### STAFF REPORT

#### Application for Site Plan Review SP-15-16 and Tree Felling Review SP-18-16 Samaritan Geary Street Clinic Expansion

DATE OF REPORT: November 15, 2016

SHEET TITLE: CONCEPTUAL LANDSCAPE PLAN  
JOB NO. 16418  
DRAWN BY: DEVCO  
DRAWING: L200

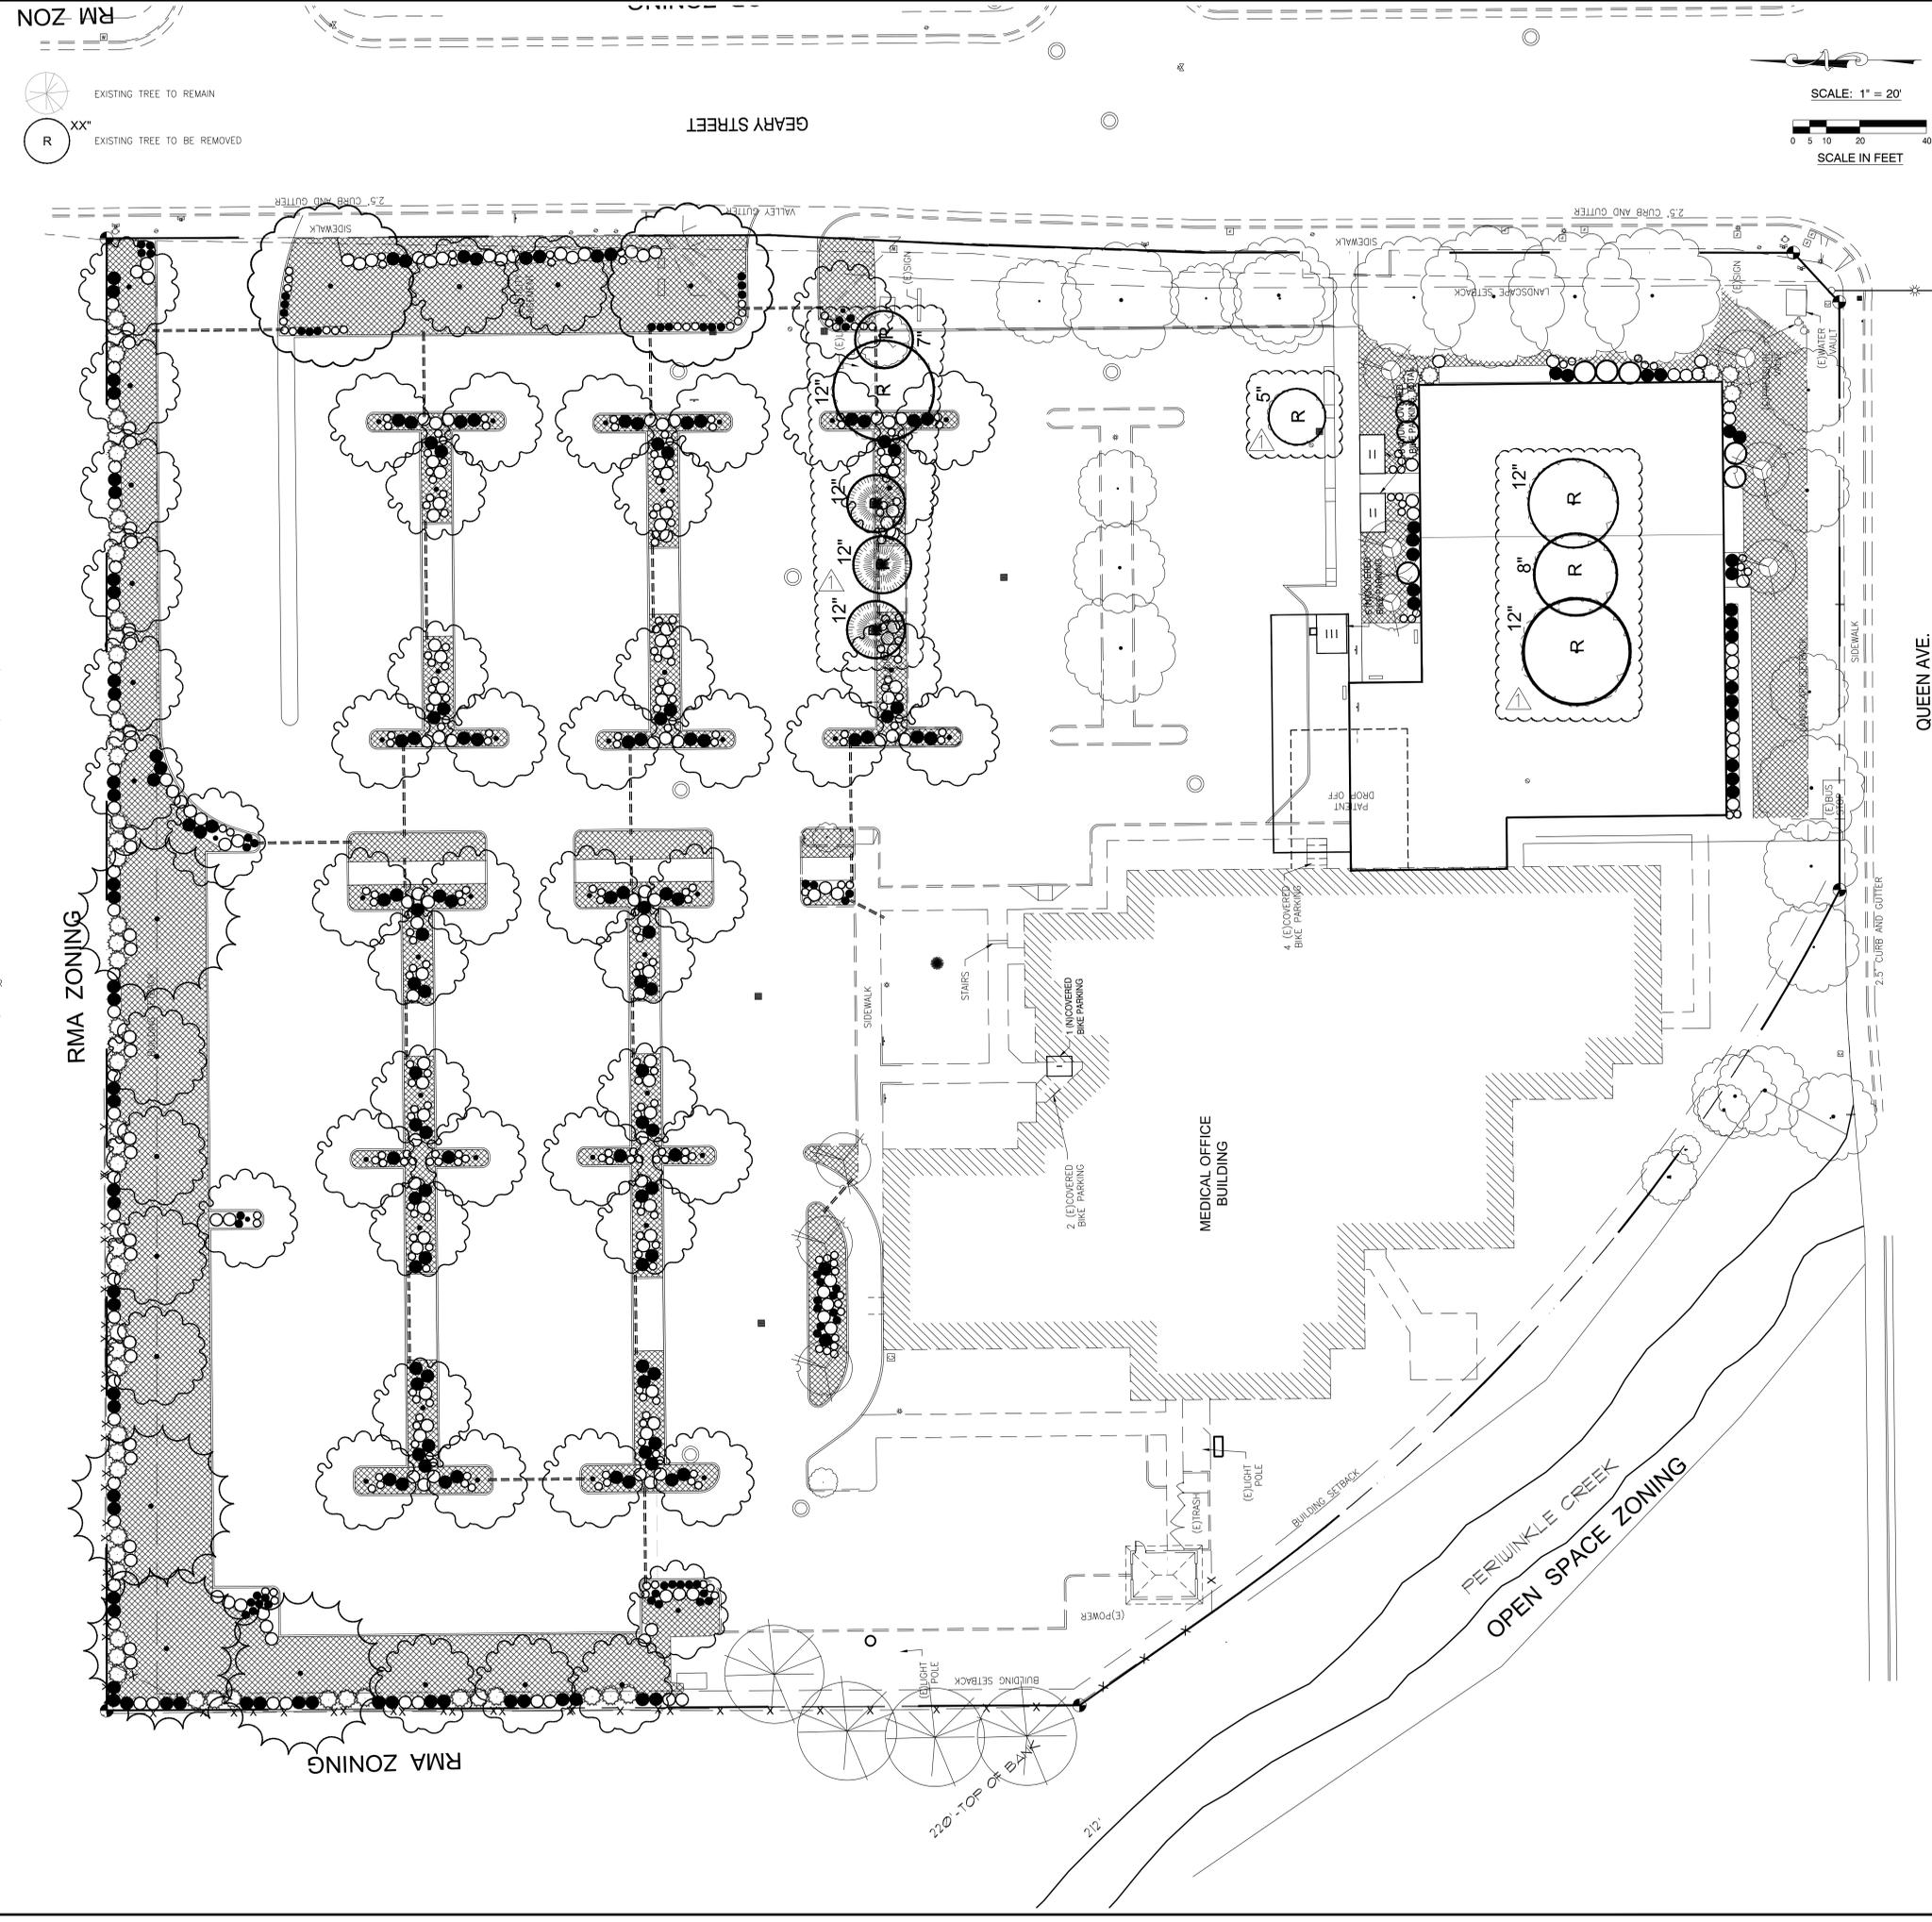
- 5.1 The operating characteristics of the proposed medical office expansion are similar to those of surrounding commercial and office uses.
- 5.2 The proposal shows that the project will meet the standards for building height, lot coverage, setbacks, parking, and environmental standards.
- 5.3 Landscaping is required along the Geary Street and Queen Avenue frontages as well as throughout the parking lot. Existing landscaping on site will be preserved to the extent that it will not be affected by the project.
- 5.4 The landscape plan is short one tree at least six feet tall along the Geary Street frontage and should be revised to clarify the location of shrubs and accent plants required along the Queen Avenue frontage.

- 5.1 A revised landscape plan that demonstrates compliance with the minimum front yard landscape requirement shall be submitted to the Planning Division for review and approval prior to issuance of a building permit. The landscape plan shall include placement of all required shrubs or accent plants from the 1997 conditional use approval (25 five-gallon shrubs or 30 one-gallon shrubs), new shrubs or accent plants associated with the present site expansion, and one additional tree at least six feet tall along the Geary Street frontage, for a total of 15 trees. The plan shall also confirm the location of required shrubs or access plants along the Queen Avenue frontage.
